PRELIMINARY NOT FOR CONSTRUCTION

A NEW MARRIOTT HOTEL
TOWNE PLACE SUITES
1400 DOM LOPEZ AVE
BAKER AND BLVD
DENHAM SPRINGS, LA 70726

SHEET TITLE: FIRST FLOOR PLAN

DRAWING NUMBER: A101

1 FIRST FLOOR PLAN
SCALE: 1/8" = 1'-0"

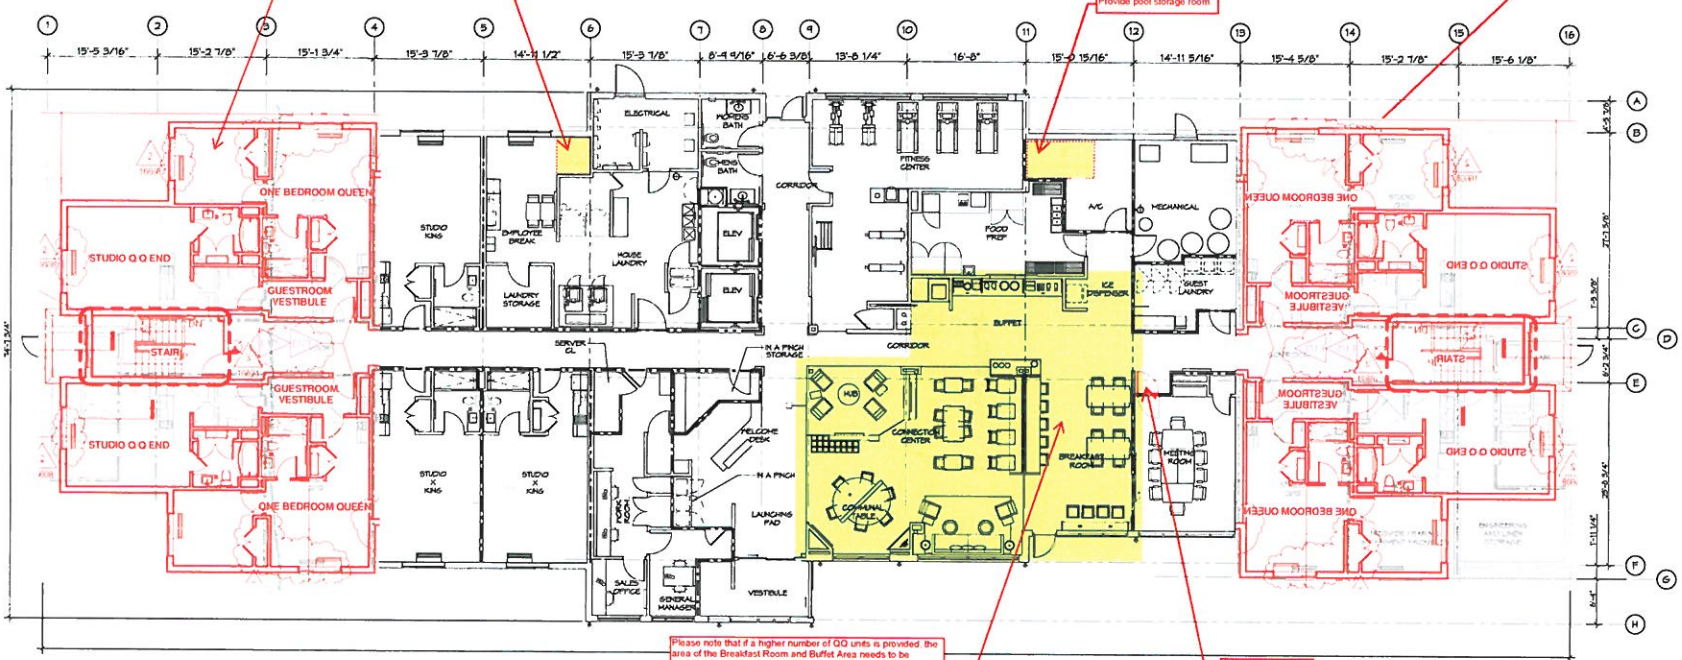
Provide "Lock-out" Units at the end of the corridor. "Lock-out units gives you the option of selling your units by separate or both of them together, depending of your market.

Consider utilizing this unused space for storage or additional seating for break room.

Provide pool storage room

Change end room configuration to accommodate 1 bedroom units. typ

Please note that if a higher number of QQ units is provided, the area of the Breakfast Room and Buffet Area needs to be increased as well as the number of seating. Note that calculation of Breakfast Room is not based on number of keys, it is based on number of beds

Swing door outward
